ADDENDUM
MEETING OF THE PLANNING COMMITTEE
WEDNESDAY 31st NOVEMBER 2018

APPLICATION: 18/01637/F – THE WARWICK SCHOOL, NOKE DRIVE, REDHILL

APPLICATION: 18/01180/F – FORMER PHILIPS RESEARCH LABORATORIES

APPLICATION: 18/01134/F- LAND TO REAR OF 19-29 SHELVERS WAY

18/01134/F - Land To The Rear Of 19-29 Shelvers Way, Tadworth

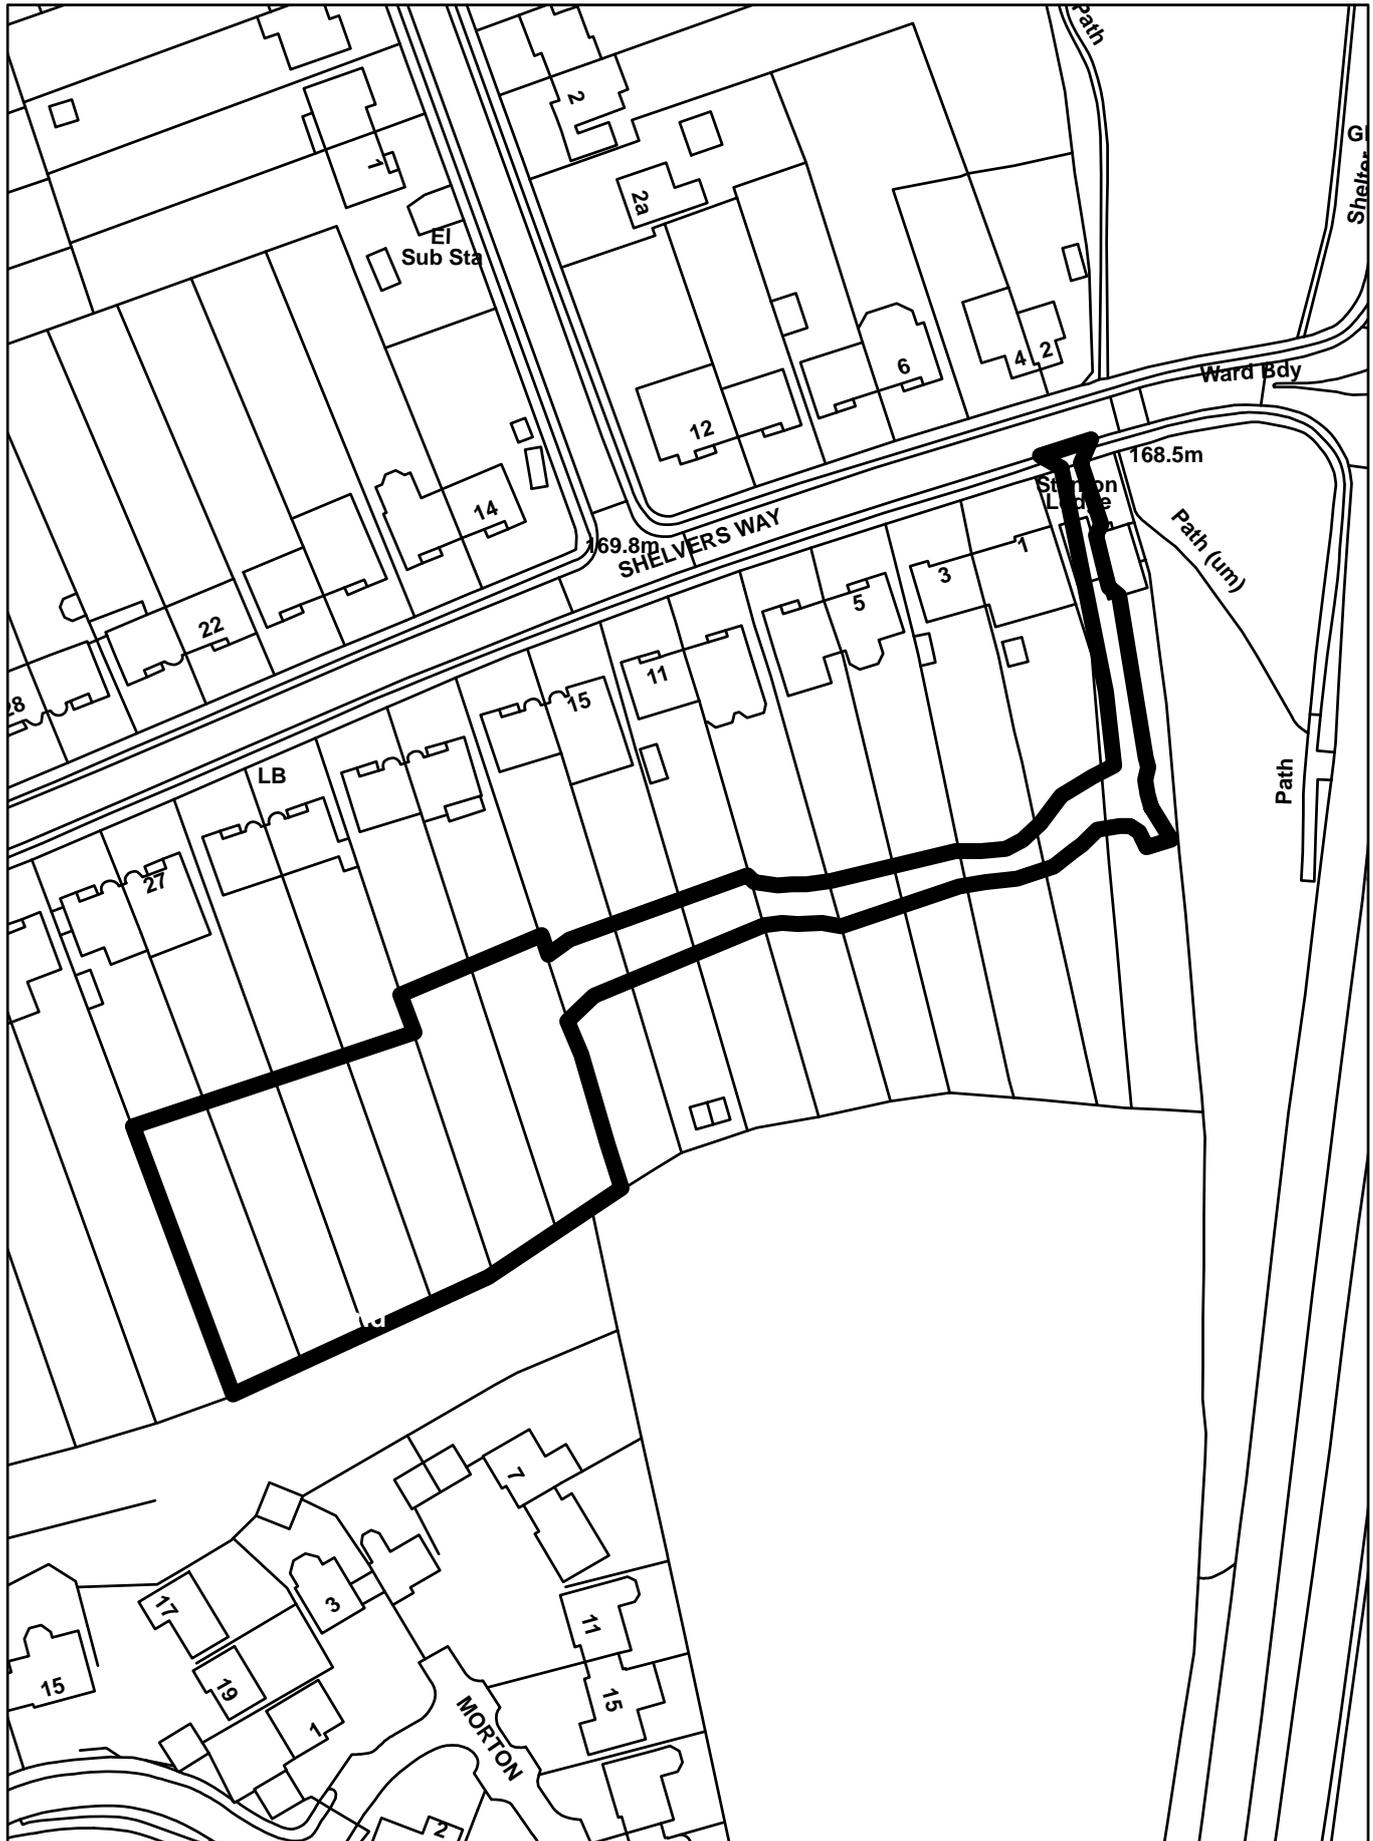
Site Plan

A site plan showing the correct application site boundaries is to be found at the Appendix A. This supersedes the plan on page 106 of the agenda.
